VILLAGE OF SUSSEX
SUSSEX, WISCONSIN

Minutes of the Architectural Review Board (ARB) meeting held on June 3, 2020.

MEMORANDUM

RE: ARB meeting for June 3, 2020

Railings with or without lights

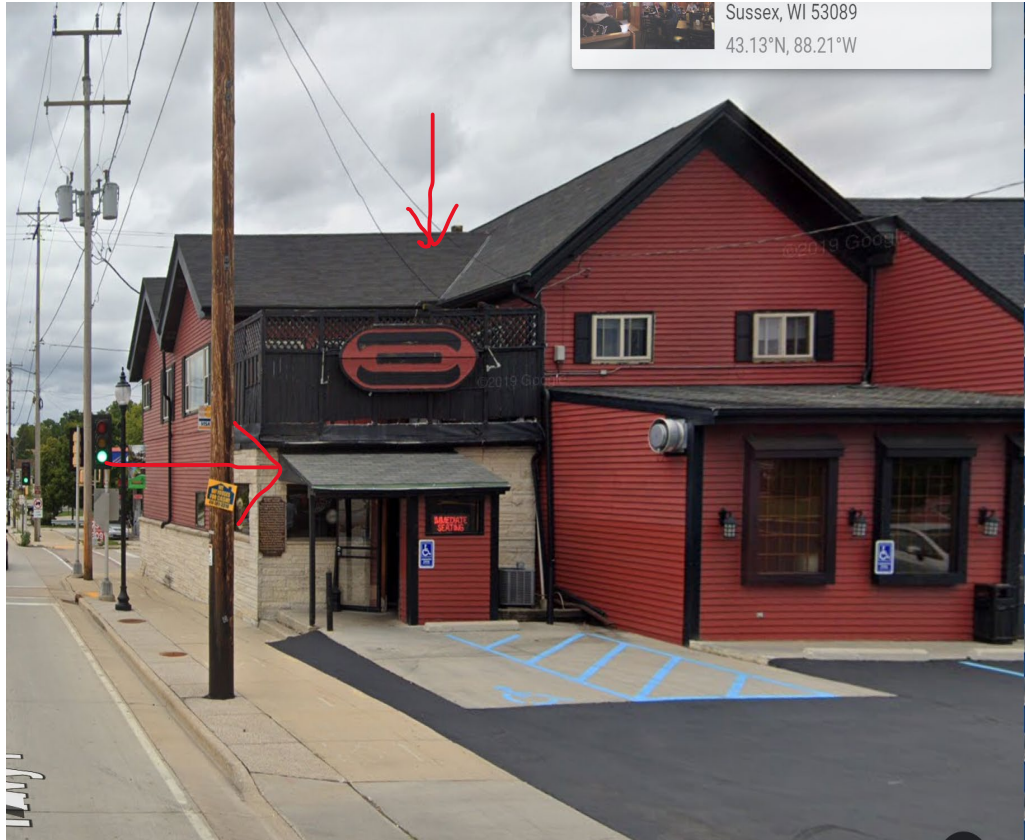
Mr. Russell stated the second floor deck and railings have become unsafe and they need to replace them. Mr. Russell reviewed the two types of fences to be considered (photo attached) he stated the fence will be black just like it is now. Mr. Russell stated the closed fence is about 6 feet tall and the open rail is about 4 feet tall. It was the consensus of the ARB the fence needs to meet the building code requirements for second floor decks.

This site is zoned B-4 Central Mixed Use District. The owner would like to make a modification to the building and because the building is located in the Downtown district the ARB reviews changes. Mr. Russell needs to repair the second floor deck of the building and is requesting to change the fence railing to use a vinyl fence material the color will be black (see photos).

Is there any concern with the new railing, material or color?

A motion by LeDonne seconded by Knapp to approve the open rail fence is acceptable in the color black and the fence rails and height are to meet the building code requirements. Motion carried.

Staff Recommendation: Staff recommends the ARB recommend approval of the fence railing, material and the color should be black to match the building trim for Belfast Station N64W23246 Main Street.
